**ADDENDUM NO. 2
TO THE BID DOCUMENTS**

Project: Homer City Hall Roof Replacement 2019
Addendum Issue Date: May 31, 2019
Bid Date: June 6, 2019 @ 2:00 PM (Thursday)
Previous Addenda Issued: 1
Issued By: Dan Gardner
Public Works Supt.
City of Homer
Homer, AK 99603
dgardner@ci.homer.ak.us

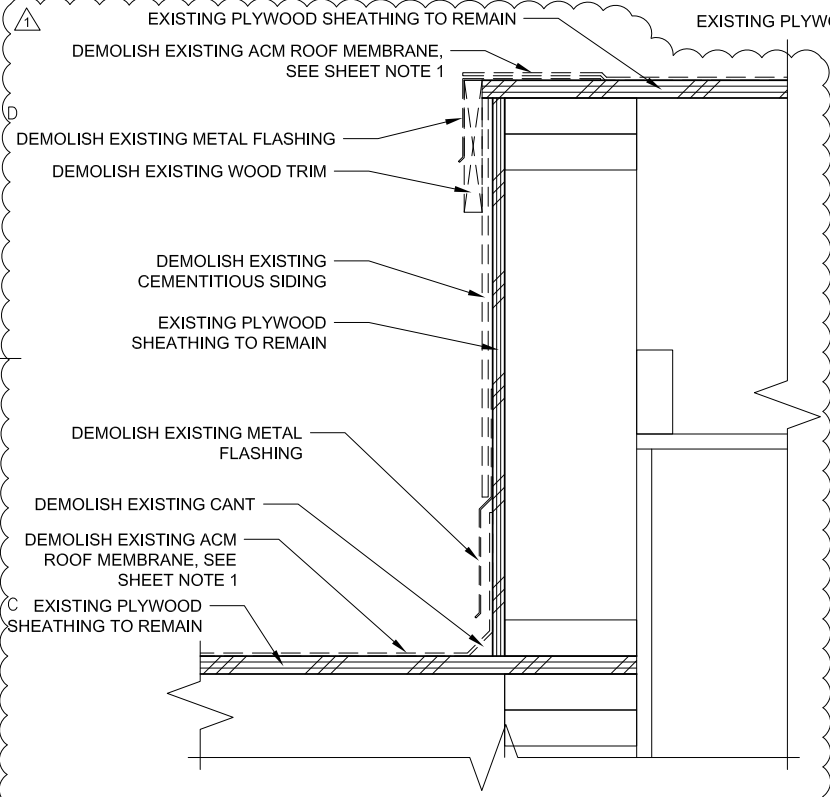
- 6.) Question: Based on detail A2 on Sheet 4.12 (below), Carlisle cannot offer a workmanship warranty for this project. It is necessary to have new cover board and new attachment to structural deck for the adhered assembly as a minimum. A material warranty is available for the 80 mil PVC membrane.

Answer: A workmanship warranty is a requirement for bidding this project. In the bid documents there is an alternate for new coverboard for roofs where new coverboard is not included in the base bid. Base-bid and alternate pricing will be utilized to determine the lowest bidder. In some cases once the roofing is removed, if the coverboard is in good shape the roofing contractor may be able to re-use the existing coverboard and provide a full warranty. The bid documents are set up to take advantage of that opportunity should it present itself.

C1 ROOF TO WALL EXISTING/DEMOLITION DETAIL A4.3 3" = 1'-0" (22x34); 1 1/2" = 1'-0" (11x17)

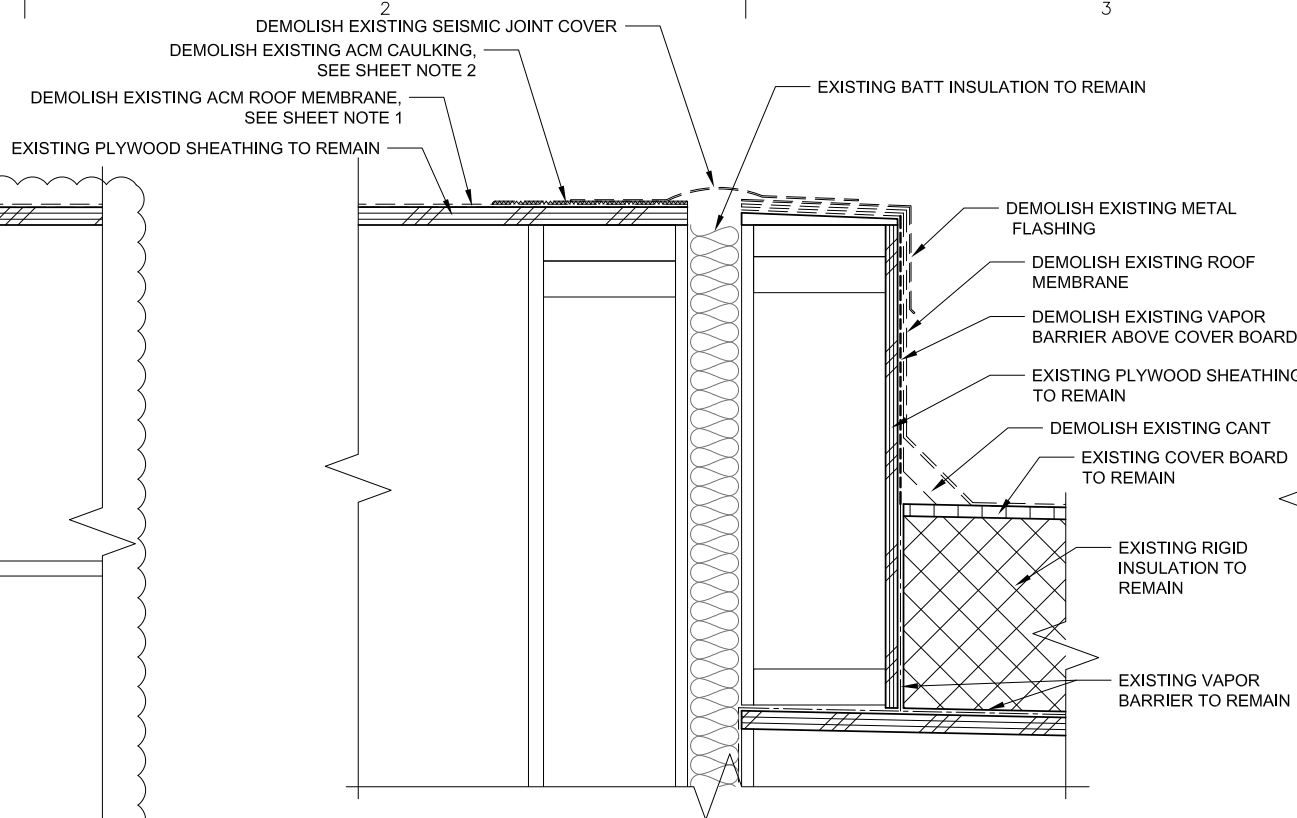
- 3.) Question: For the short wall at Roof B should the existing siding and trim remain?

Answer: In Detail C1/A4.3 Replace existing siding and wood trim with a complete metal flashing as shown in revised detail C1/A4.12.

A2 ROOF TO WALL EXISTING/DEMOLITION DETAIL A4.4 3" = 1'-0" (22x34); 1 1/2" = 1'-0" (11x17)

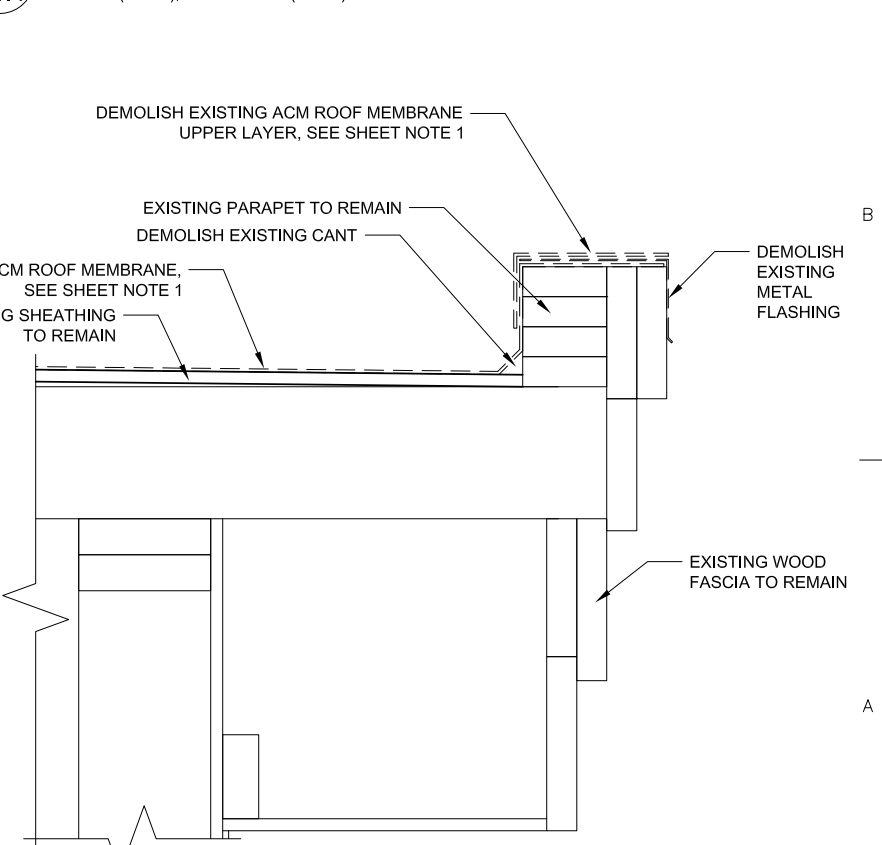
- 5.) Question: In Detail A2/A4.13 the construction adjacent to the window includes a cement panel over metal trim. Is it the city's intent that the cement board flashings removed to allow removal of nails in the existing metal trim?

Answer: Please see revised detail A2/A4.4 and refer to new detail SK-A-001 that shows the condition at the window and adjacent siding. It is the design intent that the existing siding will not be removed or modified.
